Re: Lee's Summit Downtown Market – FDP

We are responding to your comments dated November 16, 2023, and are submitting with this letter revised Plans and other required documents. Please find the original comments copied from marked up PDF Plans below; our responses are below in bold italics.

EXISTING SOUTH INLET DRAINAGE EXHIBIT

EXHIBIT
1

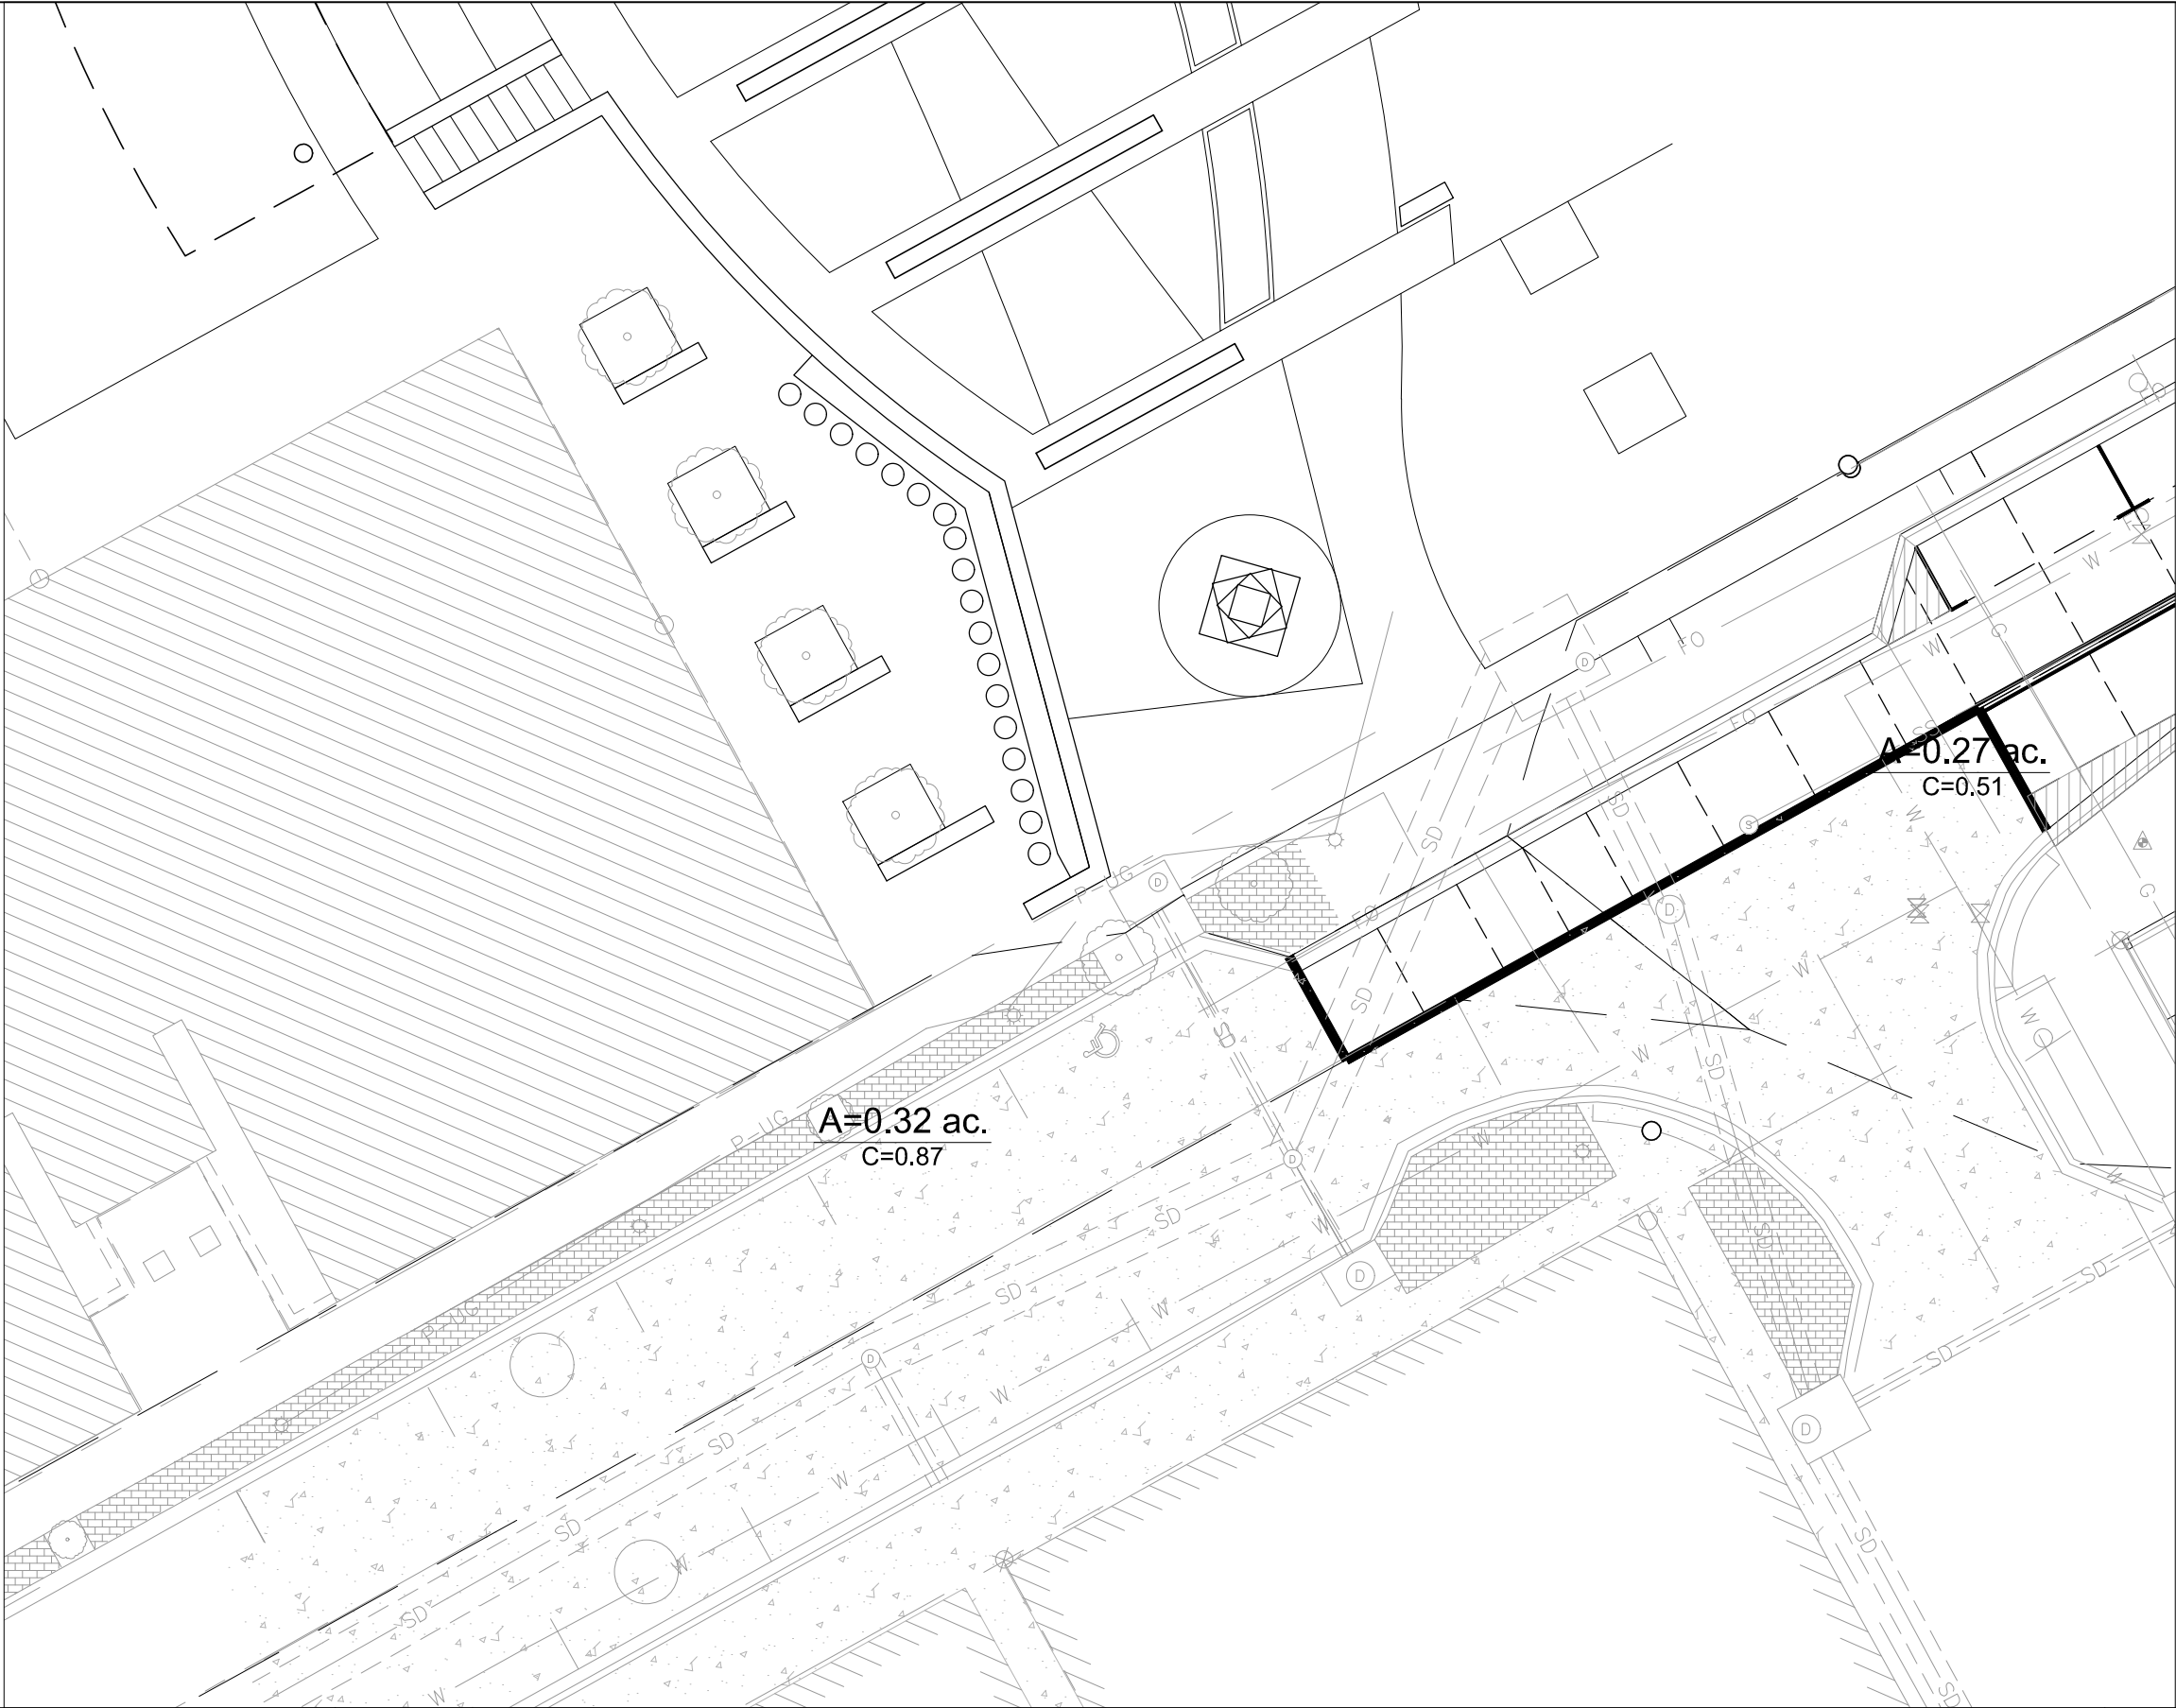
3. I have concerns about drainage at the north part of what used to be 3rd Street and what will stay 3rd Street. Please provide additional information showing what existing and/or proposed inlets will capture drainage from the site, even if public.

Response: Drainage at the north part of 3rd Street is being addressed with public street improvements. A proposed sump inlet H1 (refer to Storm Drainage Map of Public Street Plans provided for reference) and an existing sump inlet SE from the City Hall (refer to Exhibit 1 provided) will be intercepting storm drainage in the area. H1 is adequately sized to prevent ponding at 100-yr storm event.
